Access Compliance Report

Public Rights-of-Way

(Pedestrian Signals)

Intersection ID: N/A	Main Street:	Cross Street: N/A	Location: N/A
ADA ID: 9E3150931746	Signal Type: One Push Button-Non APS	Overall Compliance: No	Severity Score: BTN 1: N/A BTN 2: N/A No BTN: N/A
Codes/Mitigation Info/Possible Solution		Field Measurements/Component Compliance

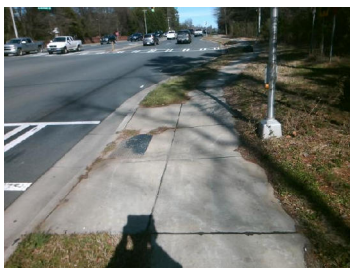
PROW/ADA: TMUTCD 4e.08, R404.2

Yes	B 1 Clear Xing Direction?	ClearlyMarked	N/A	B 2 Clear Xing Direction?	N/A
	B 1 Crossing Direction	To W		B 2 Crossing Direction	N/A
Yes	B 1 DistanceTo XWalk (in)	51.0	N/A	B 2 DistanceTo XWalk (in)	N/A
No	B 1 DistanceTo Curb (in)	102.0	N/A	B 2 DistanceTo Curb (in)	N/A
Yes	B 1 Diameter (in)	2.0	N/A	B 2 Diameter (in)	N/A

Possible Solutions: Replace Signal Push Button With APS Button on New Post. Remove & Relocate Sign.
